| Project Title: | Mission Rock Energy Center |
| Document Title: | Data Request Responses Set 1 & 1A to Data Requests 1 through 114 |

Responses to California Energy Commission Staff
Data Requests 1 through 114

Mission Rock Energy Center

Figure DR34-2a
Surface Visibility
Mission Rock Energy Center
Ventura County, California

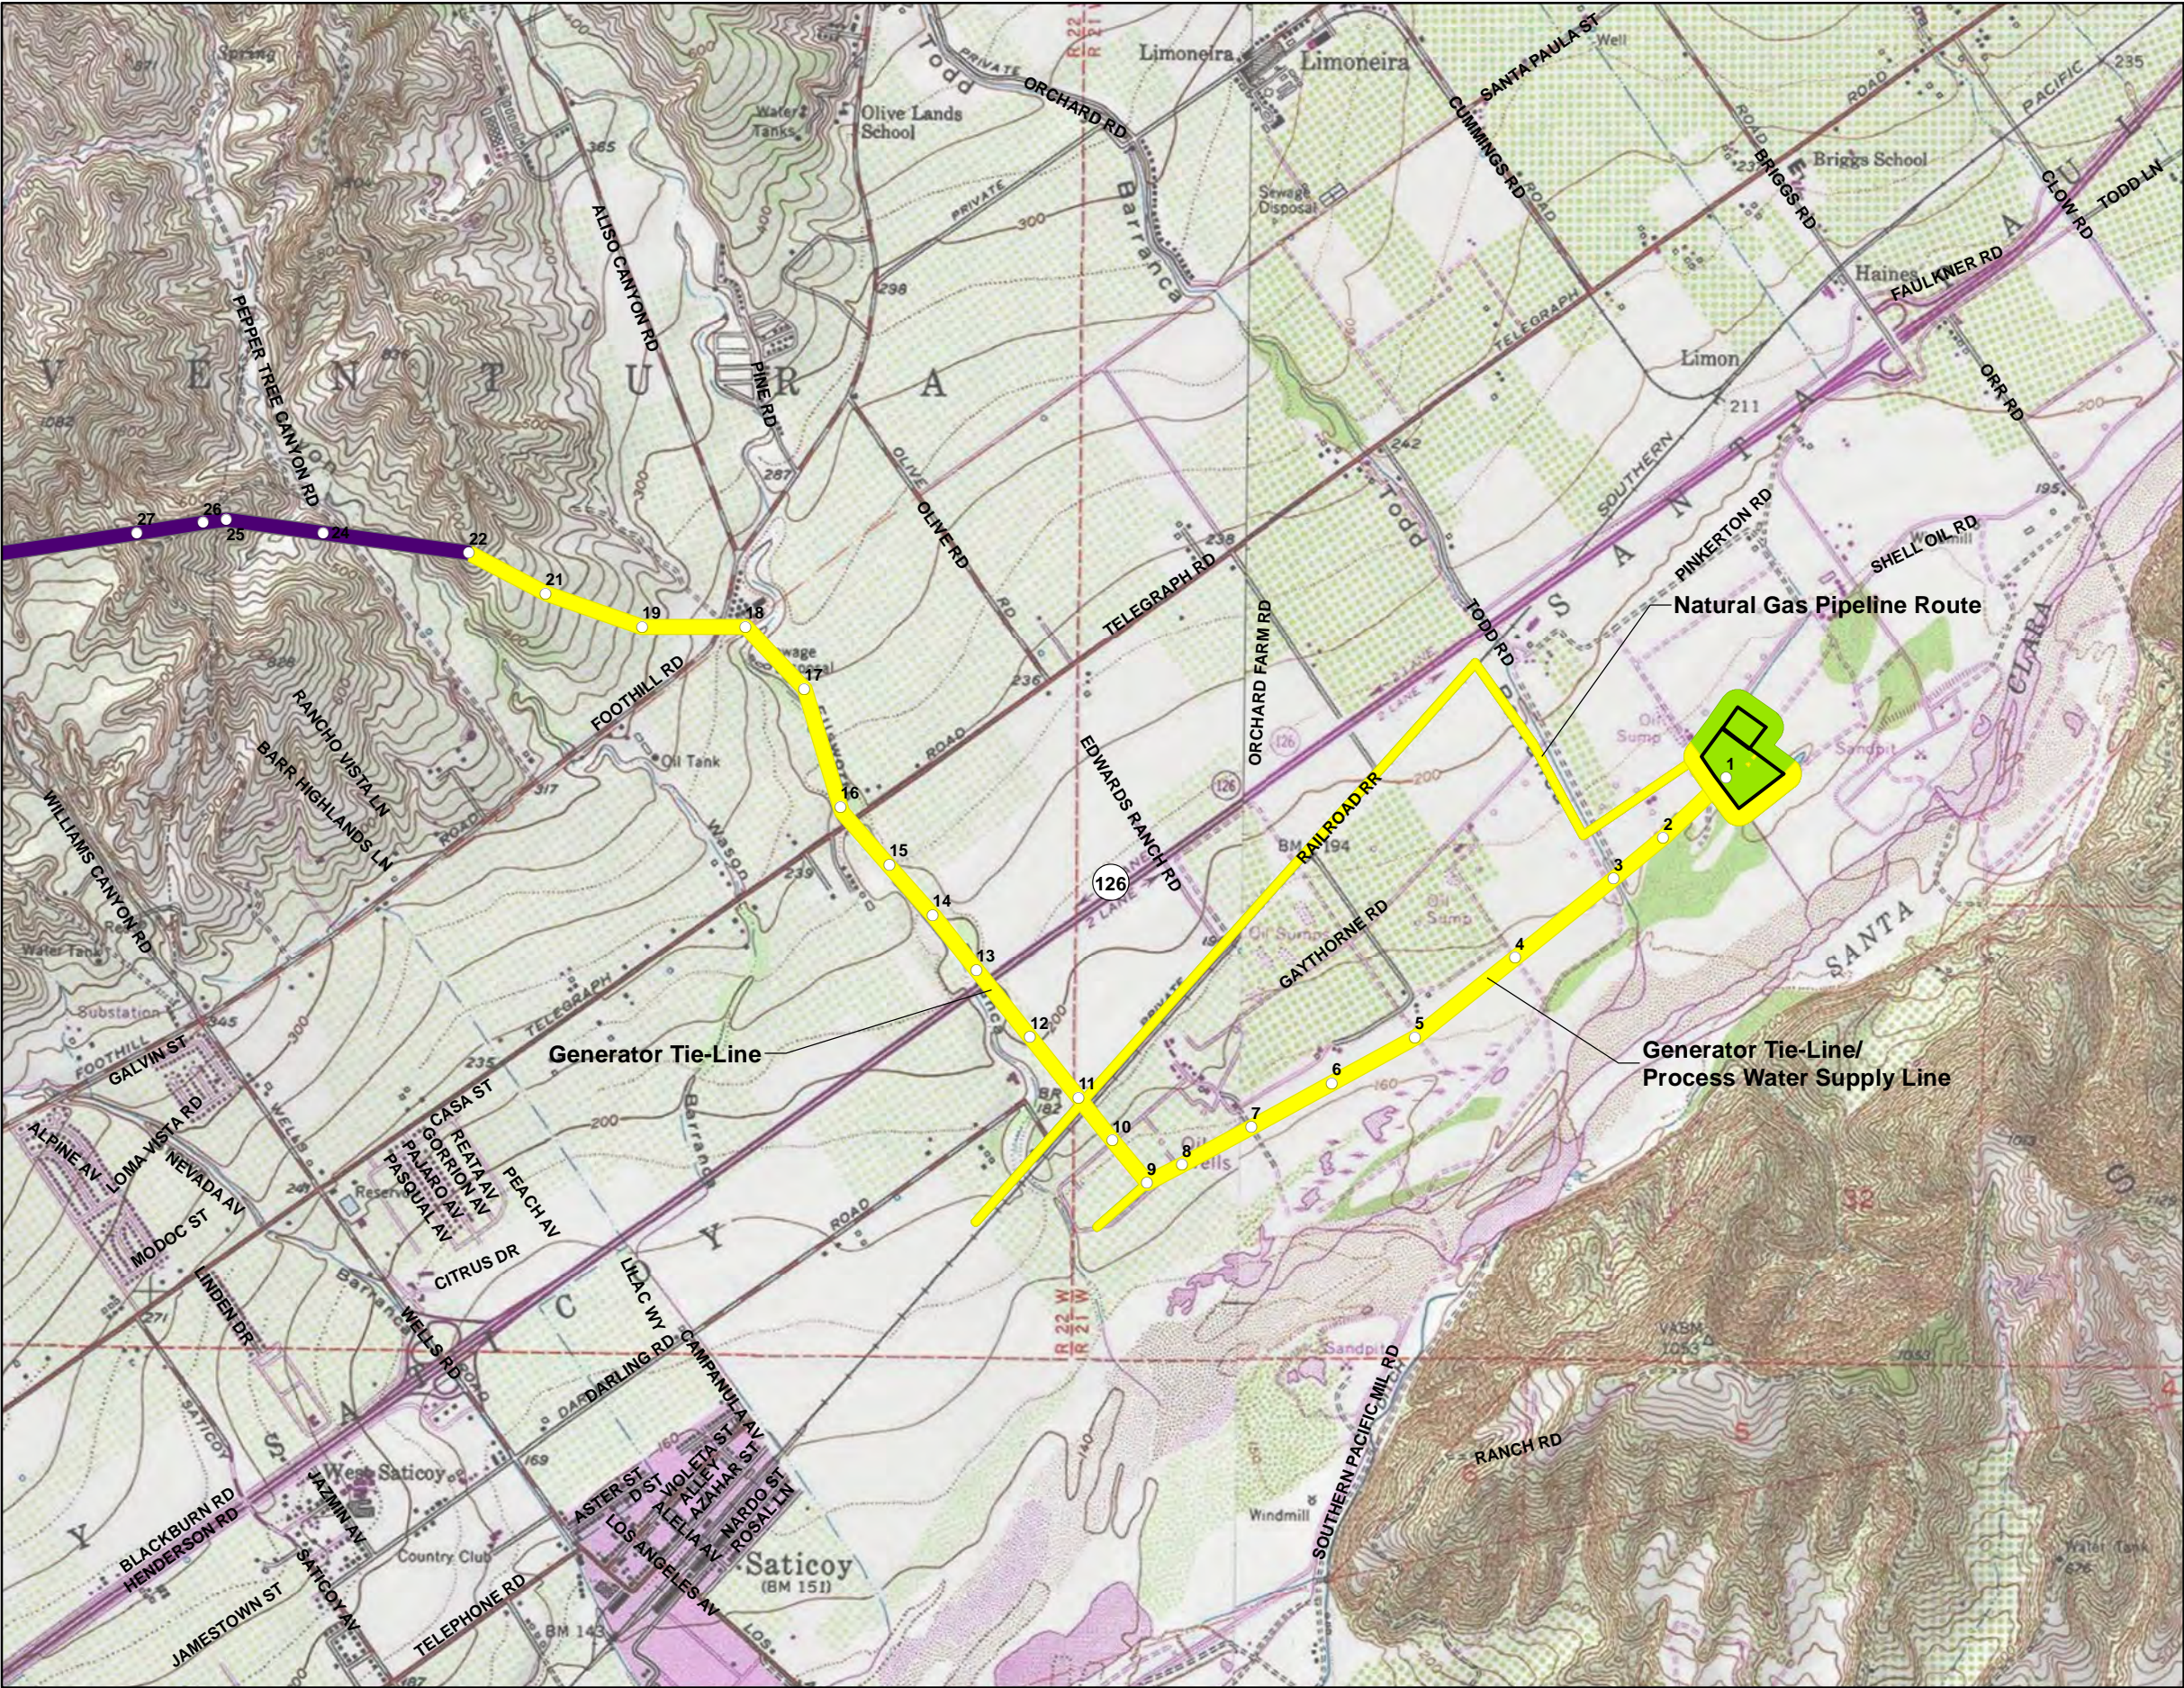
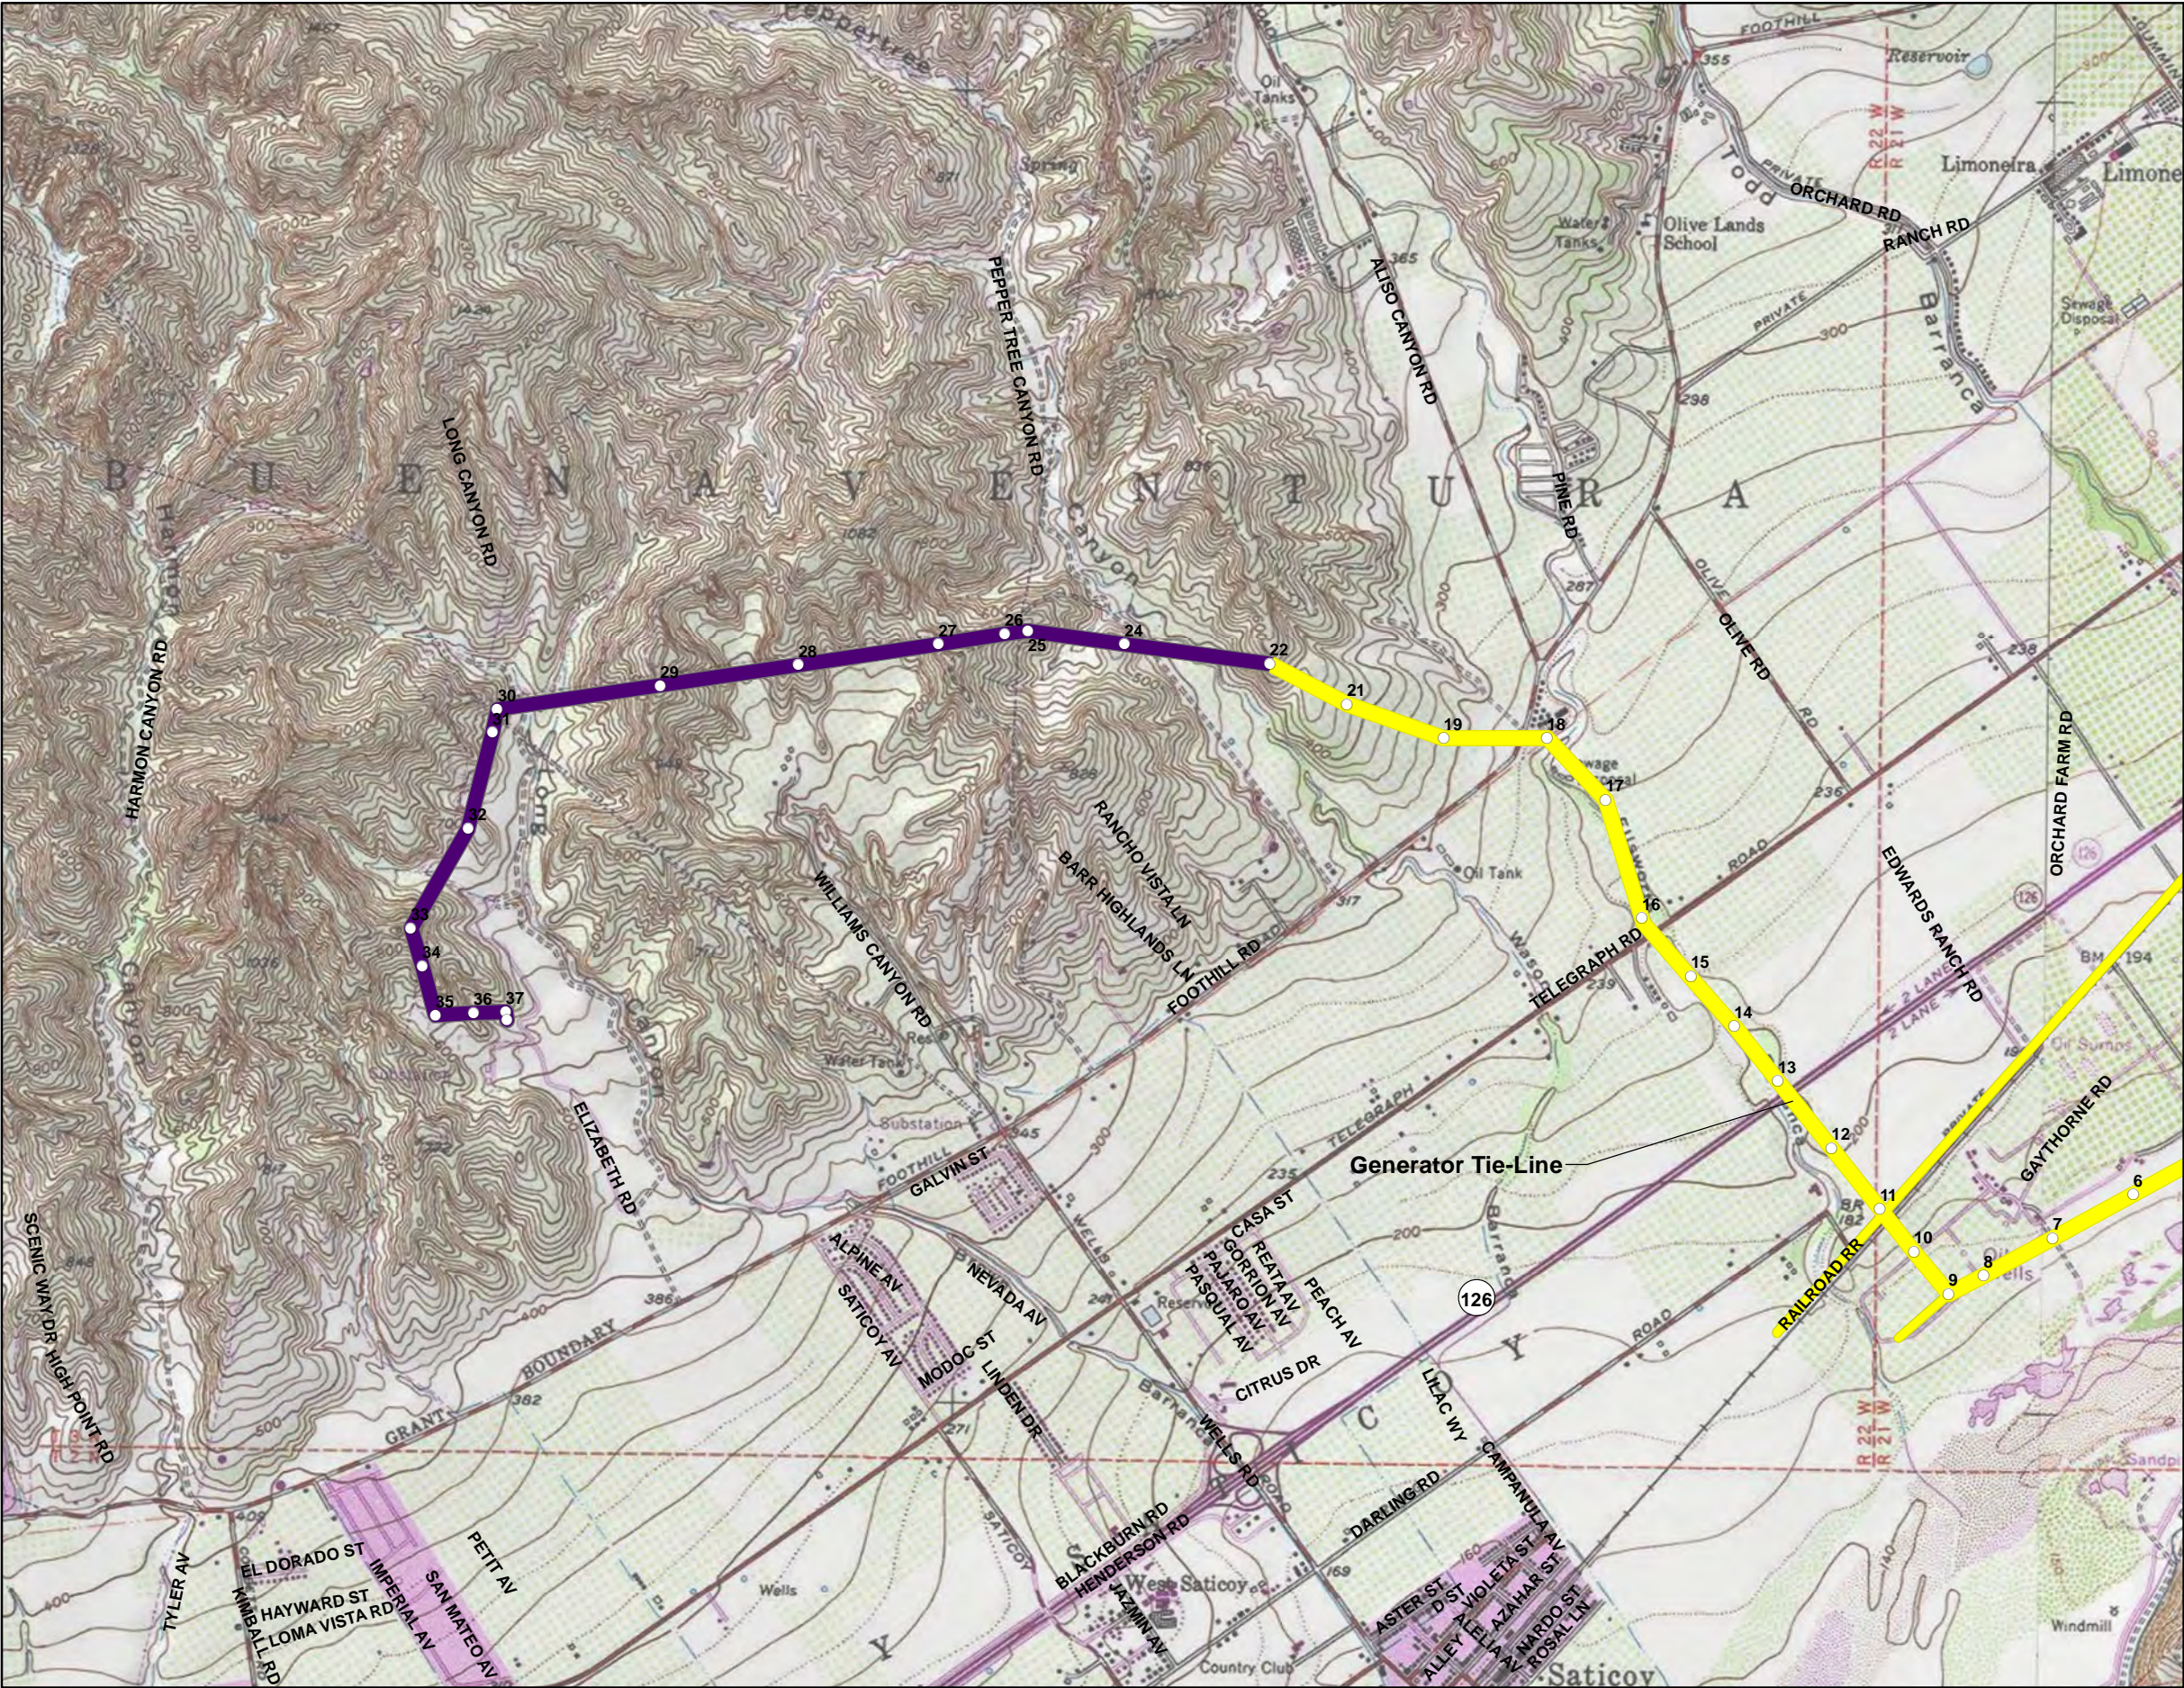
34. *Please provide figures that indicate areas with slope greater than 25 percent and areas that remain unsurveyed in the archaeological resources study area. The figures shall conform to the following requirements:*

Response: Figure DR34-1 shows the areas of slopes greater than 25 percent in the study area. Figure DR34-2 shows the surface visibility throughout the study area.
